HEARING DATE: March 12, 2024

TO: Mayor & City Council

SUBJECT: Avani Neighborhood AZ, PP  
H-2023-0049

Annexation of 35.086 acres of land to the R-15 (Medium-high-density residential) zoning district; and Preliminary Plat consisting of 256 building lots and 25 common lots on 33.71-acres of land in the R-15 zoning district for Avani Neighborhood Subdivision.

D. Common Drive Exhibit – *NOT APPROVED*

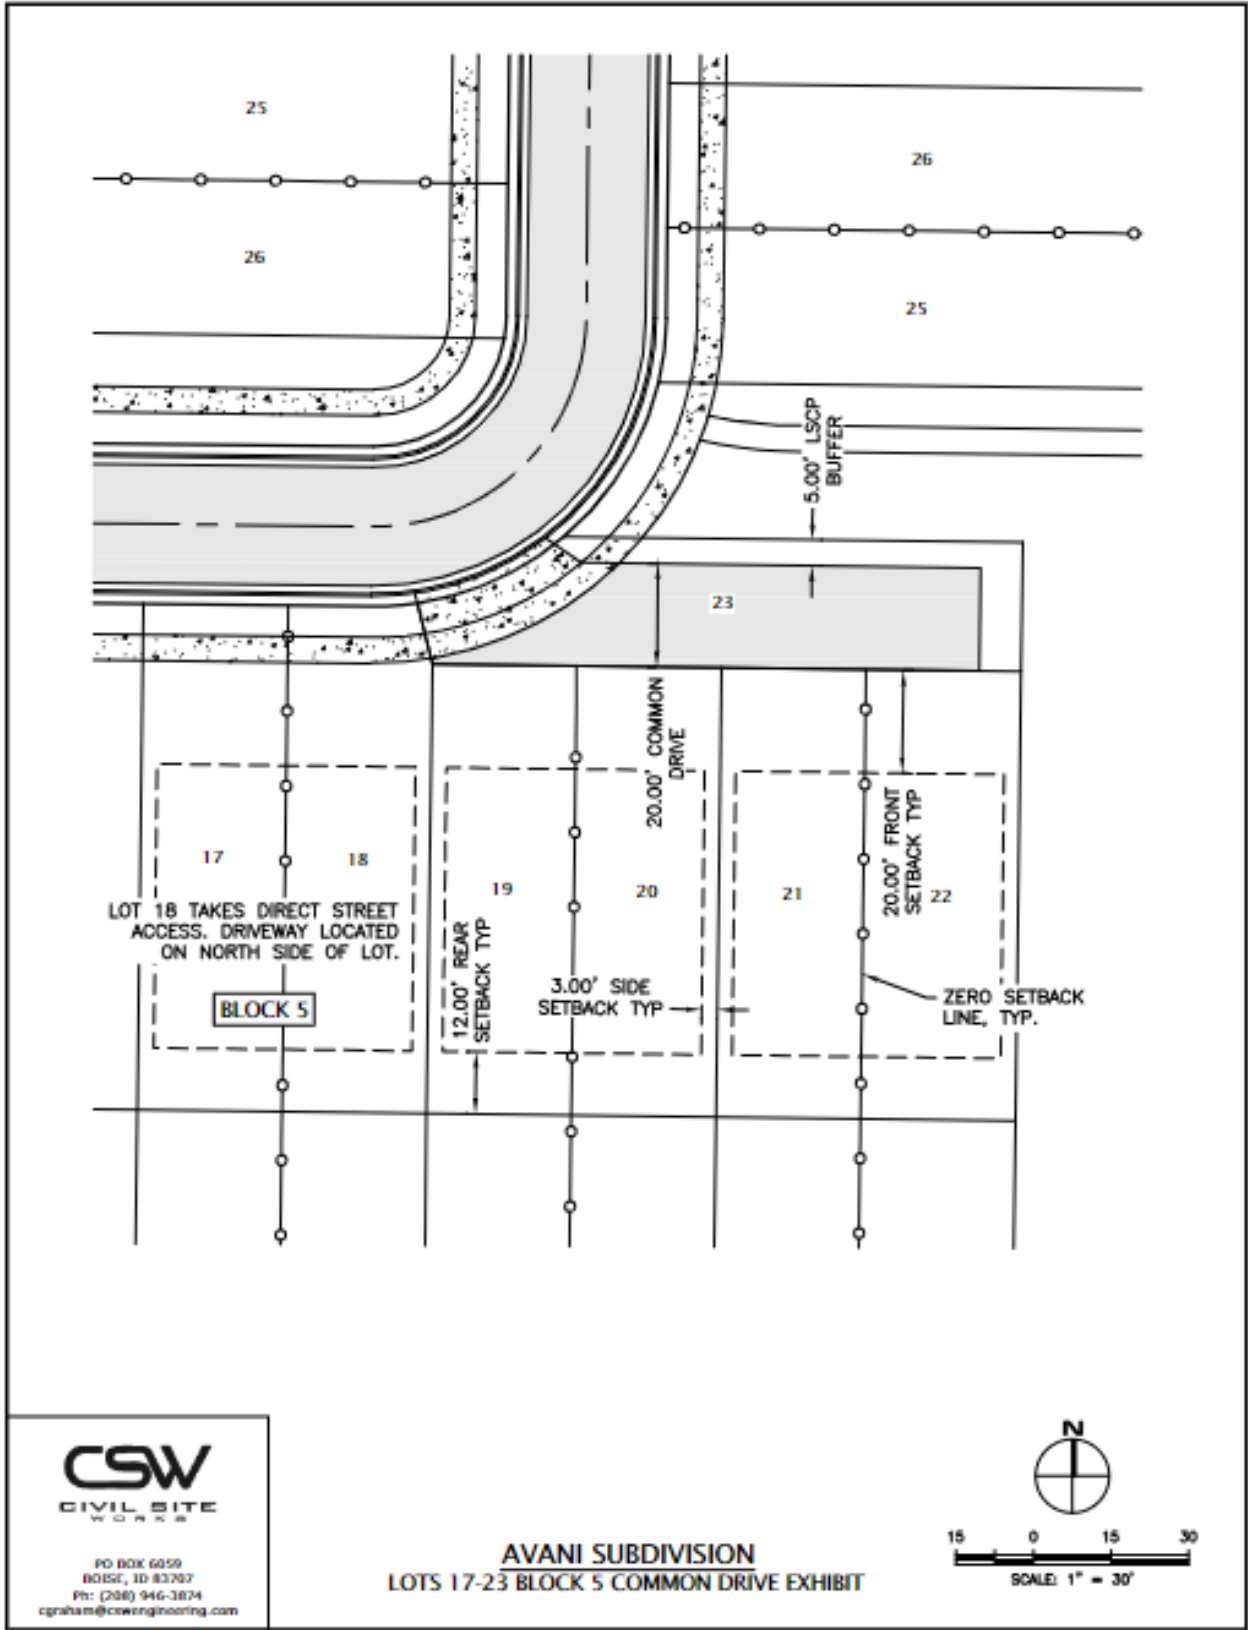
Local streets, alleys, and common drives are proposed internally for access to the proposed residential units. **Staff believes the plat should incorporate more alley-loaded lots however, the Applicant believes there isn’t a market for this type of housing and has elected to limit the number of alley-loaded homes to ten (10) which is inconsistent with the Plan.**

*Out of the 256 single-family units, only 10 are alley-loaded; the others are all front-loaded with living area either at the same plane or behind the garages away from the street. A few of the units have usable porches that might meet the guidelines. No porches are proposed on the side facades. All units have single 2-car garage doors, not separate doors.*

A preliminary plat is proposed consisting of 256 [95 single-family attached, 10 alley-loaded, and 151 single-family detached units] building lots and 25 landscape, six (6) common driveways, two (2) alleys, and one (1) non-buildable lot on 33.707-acres of land in the R-15 district. Proposed lots range in size

**Common Driveway (UDC [11-6C-3D](#)):** Six (6) common driveways are proposed within the development of the site on Lot 42, Block 1, Lot 16, Block 1, Lot 41, Block 2, Lot 33, Block 2, Lot 16, Block, 2, and Lot 23, Block 5. Common driveways are allowed to serve a maximum of four (4) dwelling units; in no case shall more than three (3) dwelling units be located on one (1) side of the driveway. **A total of four (4) dwelling units are proposed on the south side of driveway for Lot 23, Block 5; the final plat and common driveway exhibit shall be revised to depict a maximum of three (3) units on one (1) side of the driveway as required; or, alternative compliance may be requested as set forth in UDC [11-5B-5](#).**

**The proposed elevations are *not* approved and should be revised to incorporate traditional neighborhood design elements as set forth in the TMISAP, as noted above in Section V, and in the Architectural Standards Manual (ASM).**
